CONTRACT NO. 1815

Miscellaneous Sewer Improvement 2025-2026

ADDENDUM NO. 3

ATTACHMENT D: DRAWING SET WITH UPDATED DETAILS ON SHEETS 11 & 12 (2 pages)

1815_C08_PLN_03
C-08 STRUCTURE
PROPOSED UPPER AND LOWER PLAN

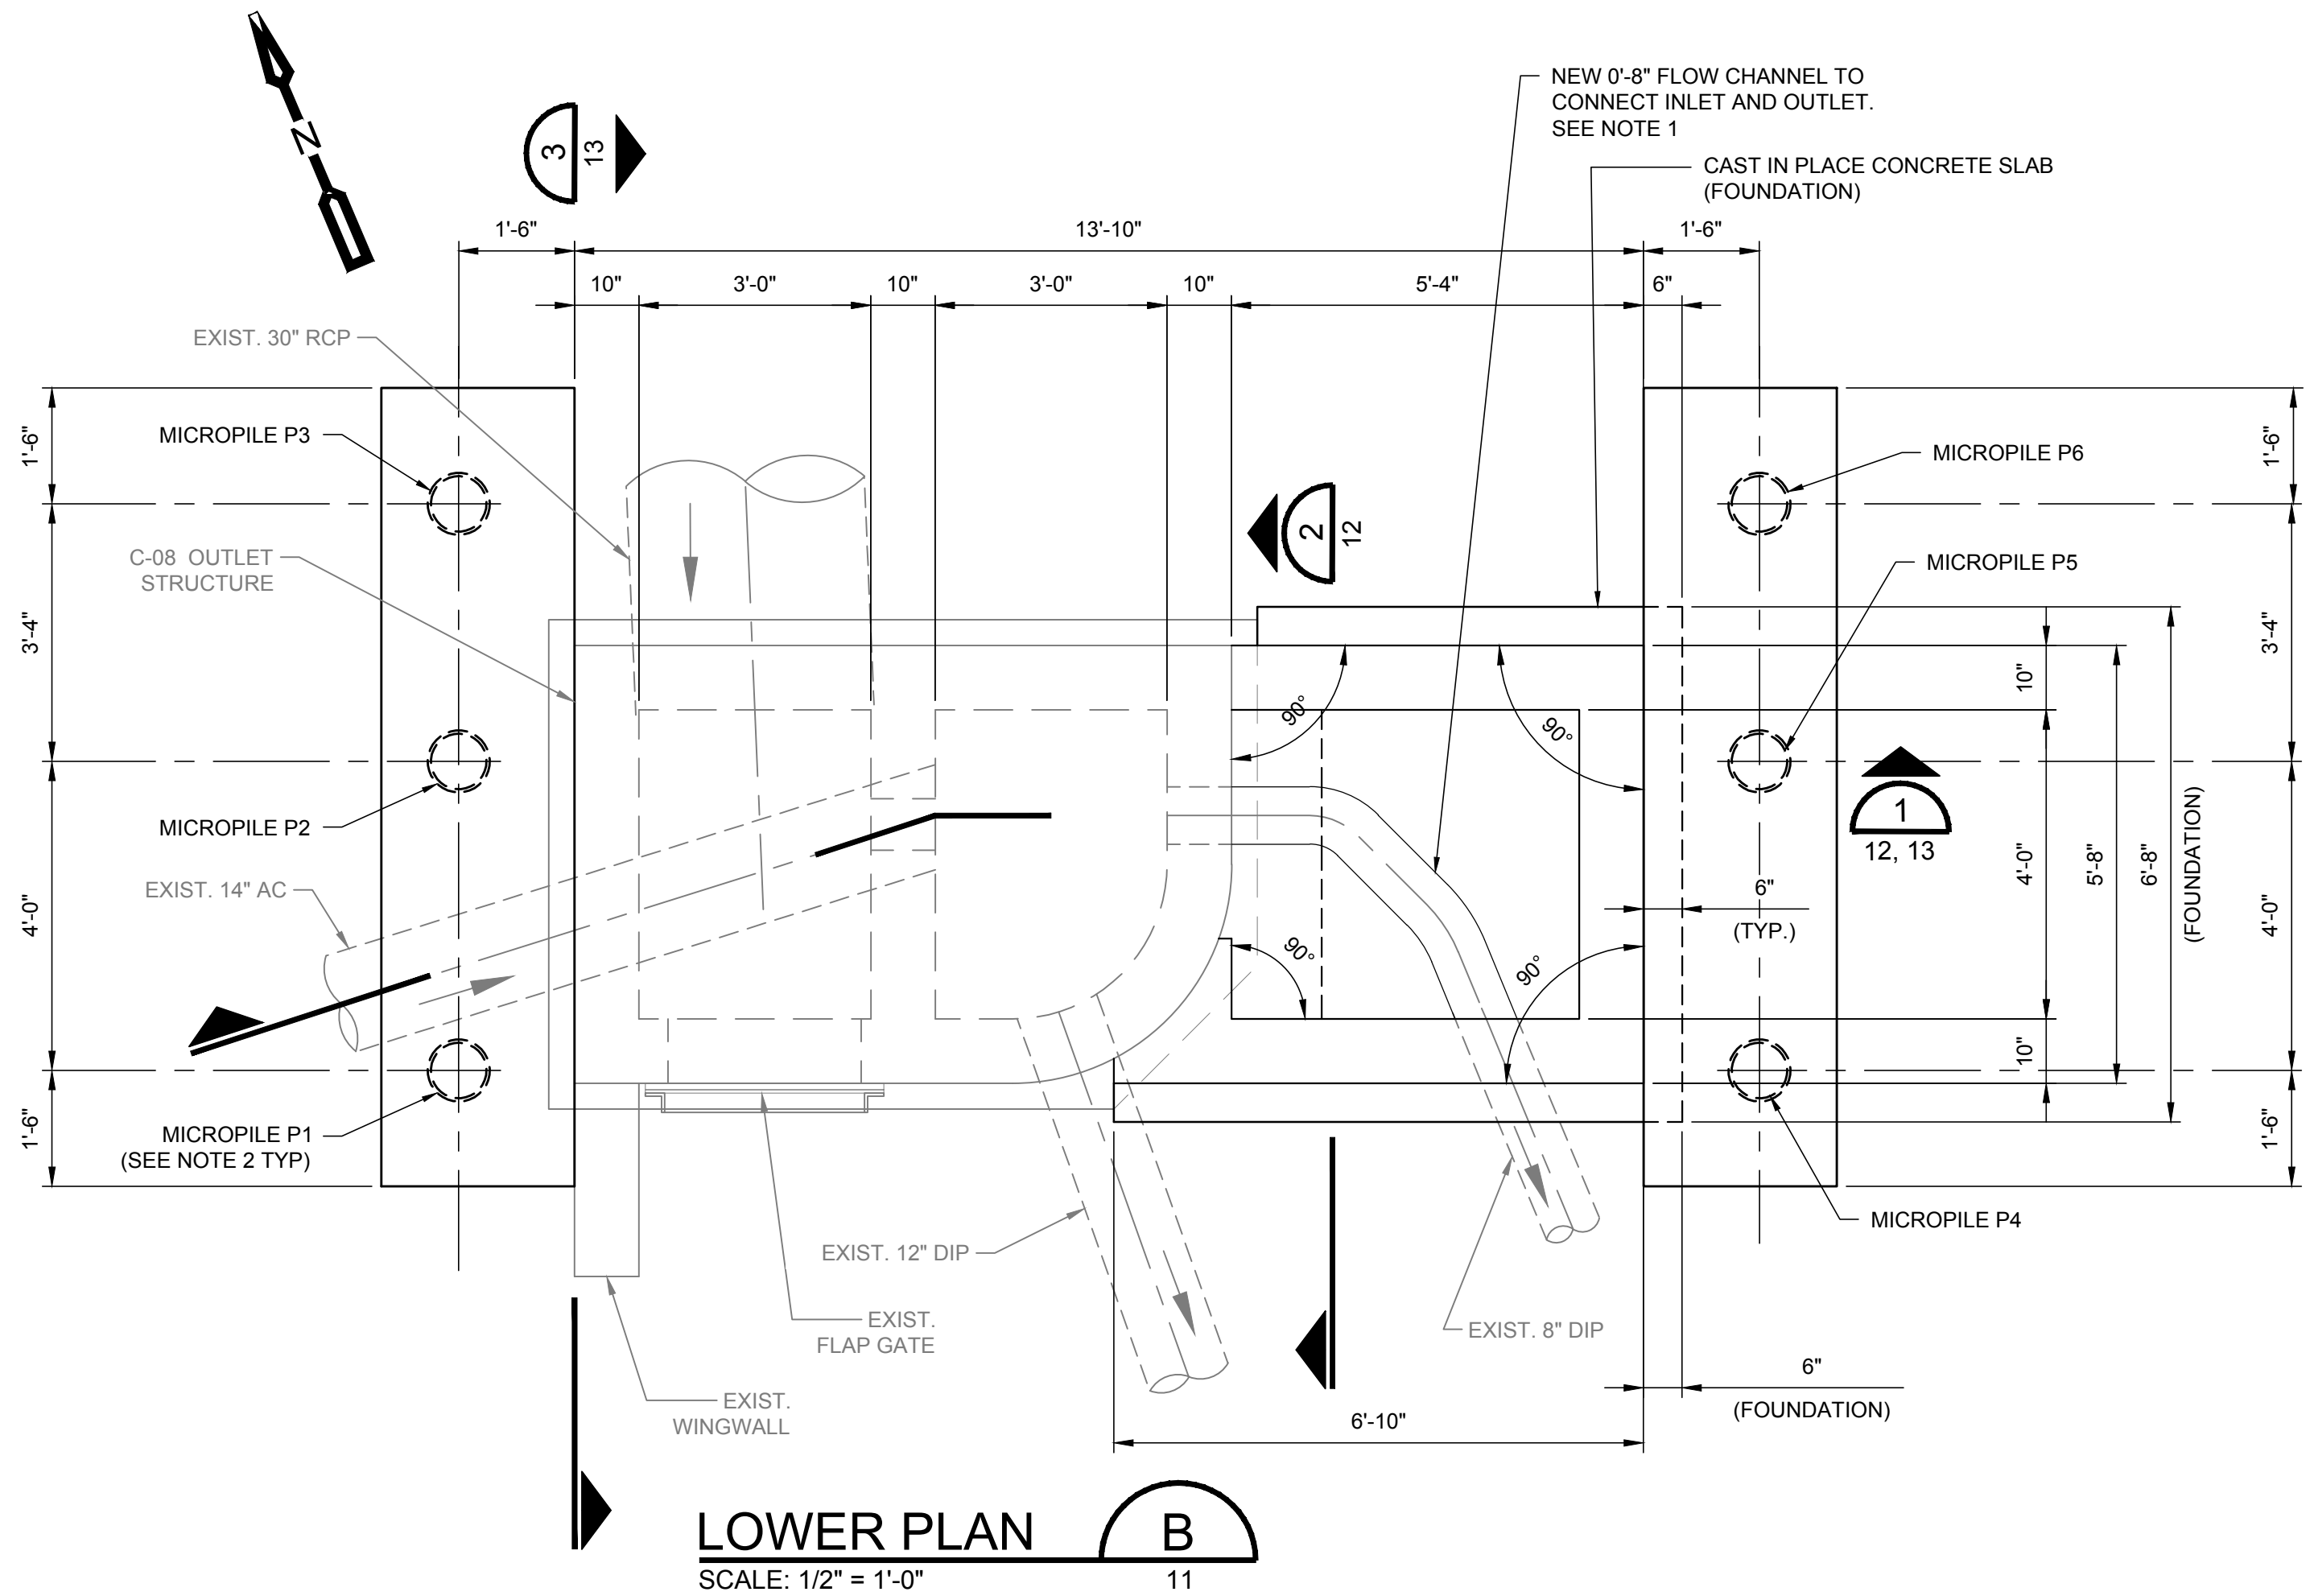
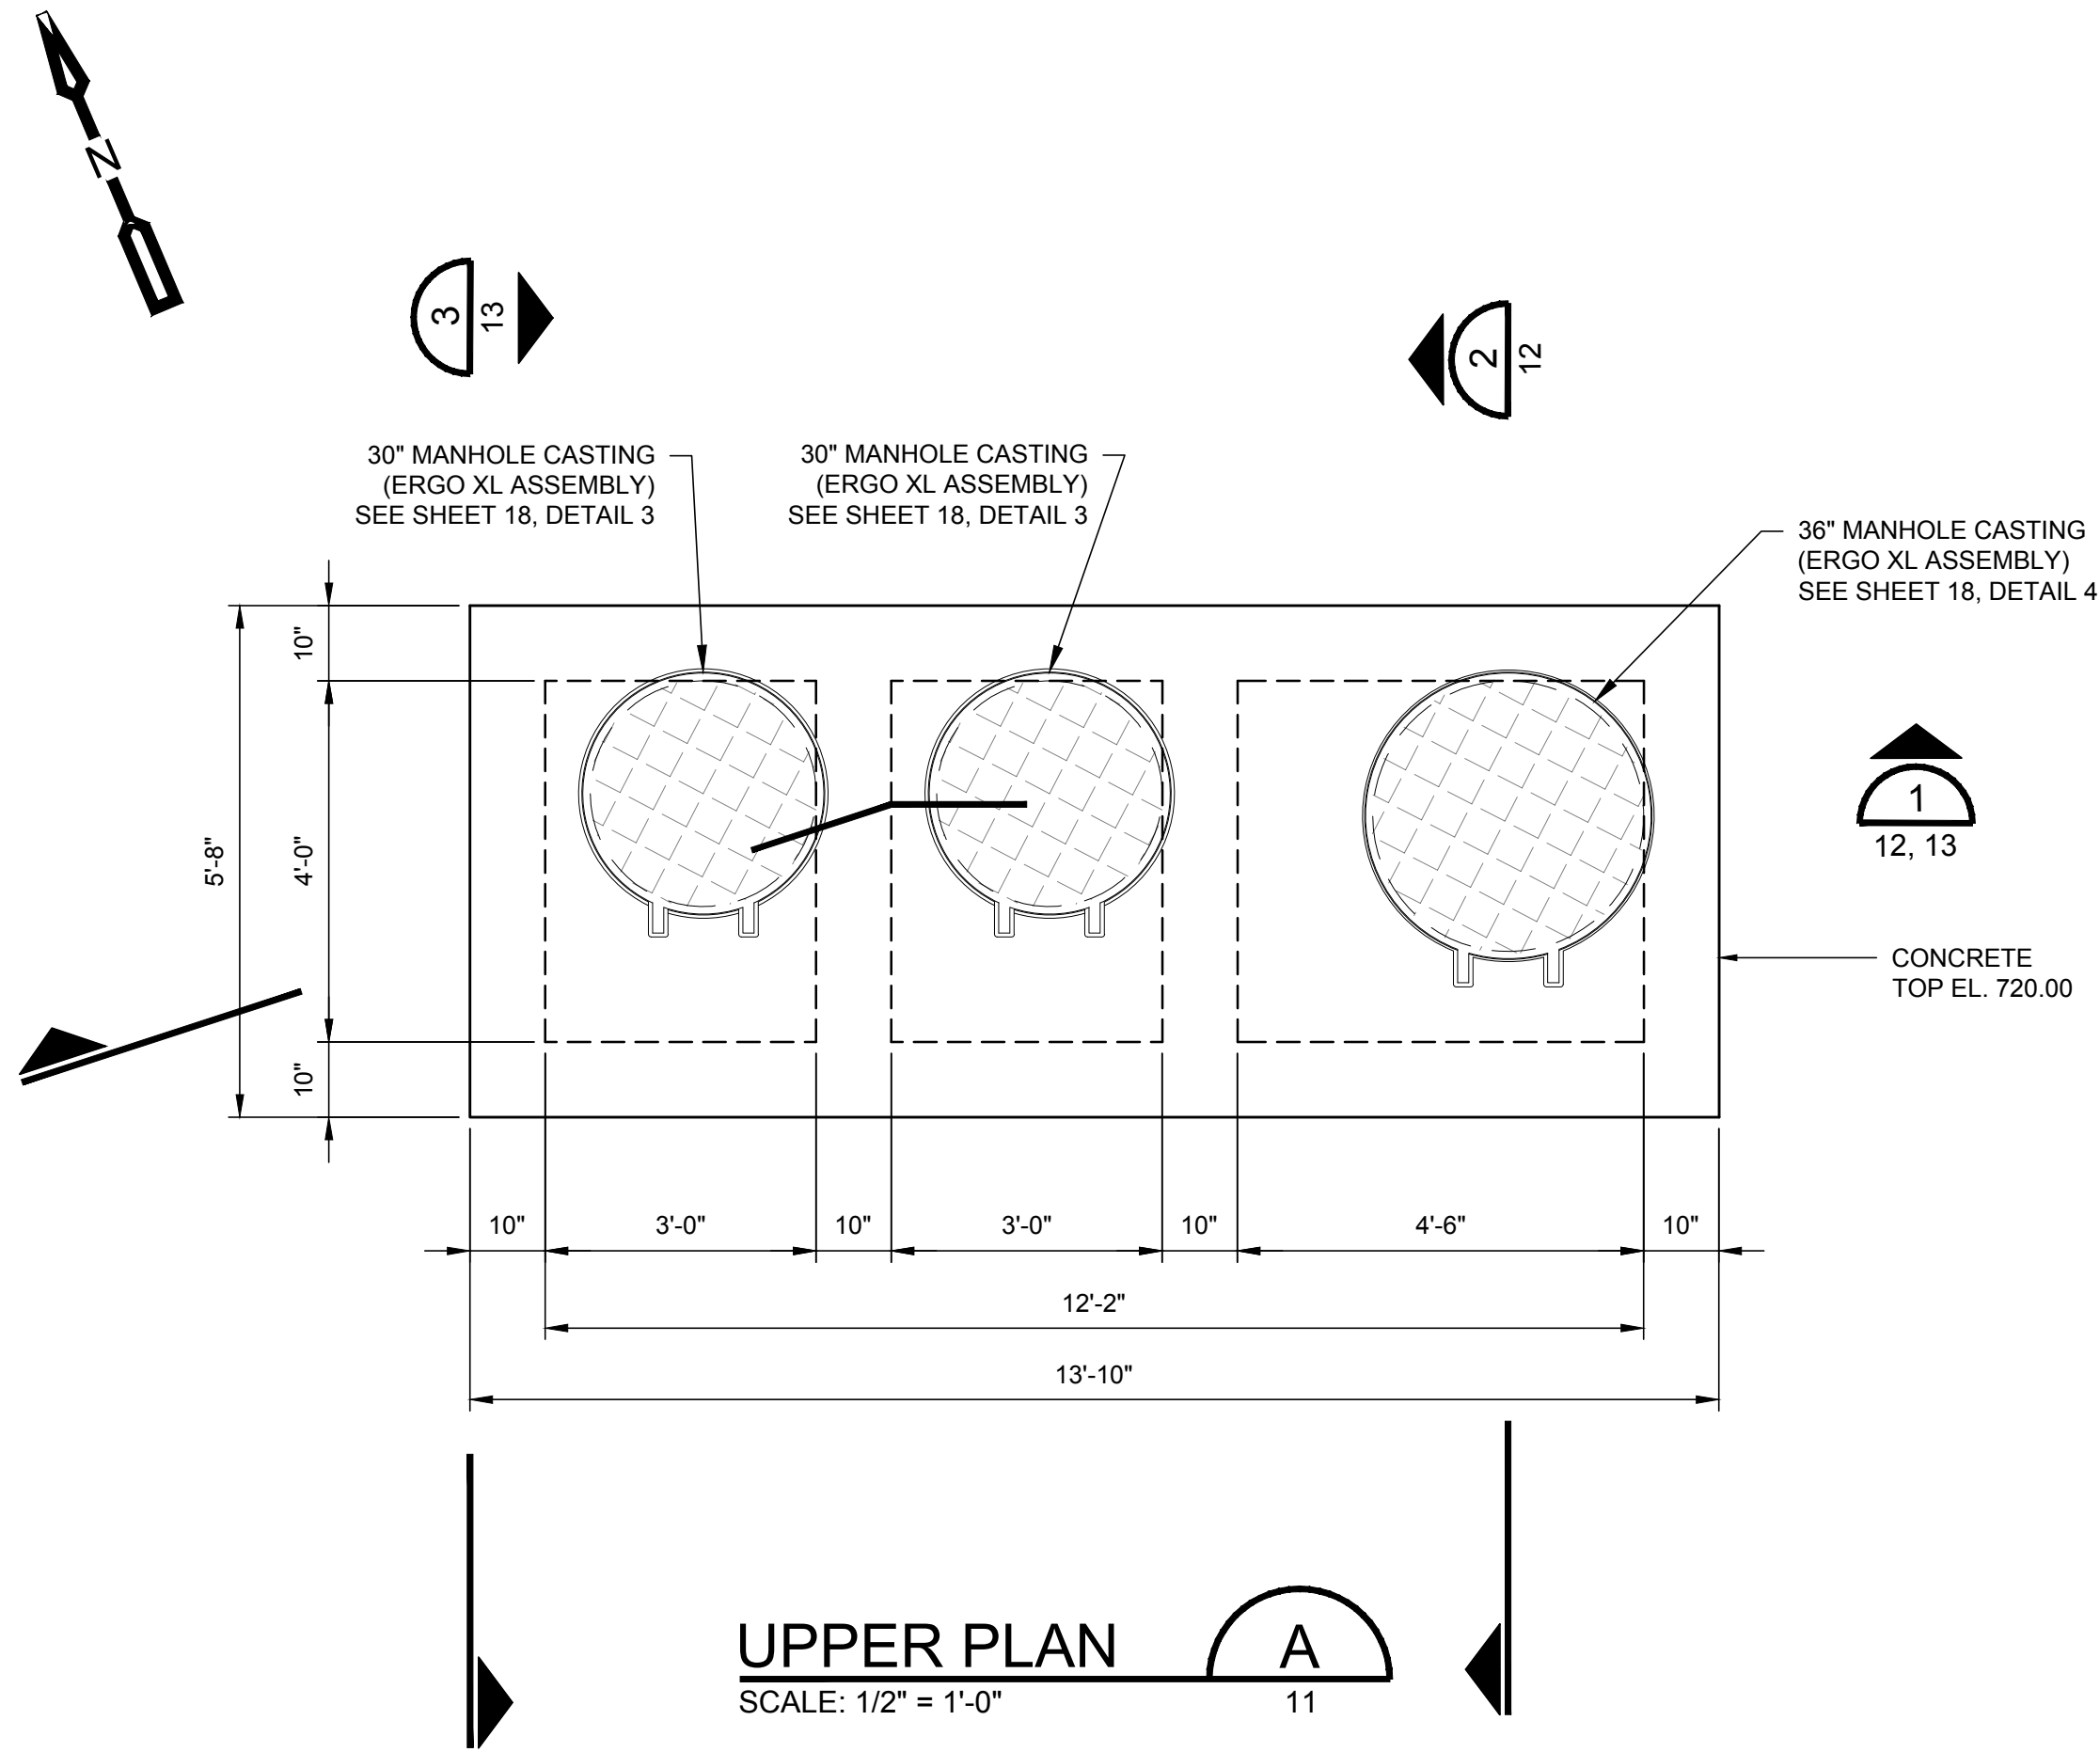
- 1.** The PennDot DM4 requirement noted in the specs affects the ultimate load and thereby leads to large sized micropiles. Please advise if this was the intended size for the micropiles.

Response: For micropile design purposes, lateral loads due to 500 psf construction surcharge and the lateral soil loads do not need to be considered concurrently. The designer shall consider the worst case of lateral load from construction surcharges and soil loads separately combined with other loads from appropriate loading (vertical dead, live and uplift loads). Also note allowable deflections are 0.5 inches at a single pile head and shall be calculated utilizing service level loads per specification 02466 Par 1.05 Art A.5. Notes will be added the micropile load schedules on Sheet 11 and 22 to clarify both of these points.

- B = LOADS DUE TO THE 100-YR FLOOD. (WSEL = 730.00).
- IT SHALL BE ASSUMED THAT LATERAL LOADING DUE TO CONSTRUCTION SURCHARGE LOADING (L) AND IN-SITU SOIL PRESSURE WILL NOT OCCUR SIMULTANEOUSLY. ACCORDINGLY, THE CONTRACTOR SHALL CONSIDER THE GREATER OF TWO LATERAL LOAD CONDITIONS TO PRODUCE THE WORST-CASE LATERAL DEFLECTION AND AXIAL/BENDING INTERACTION ON THE PILES DURING DESIGN USING THE APPROPRIATE LOAD COMBINATIONS.
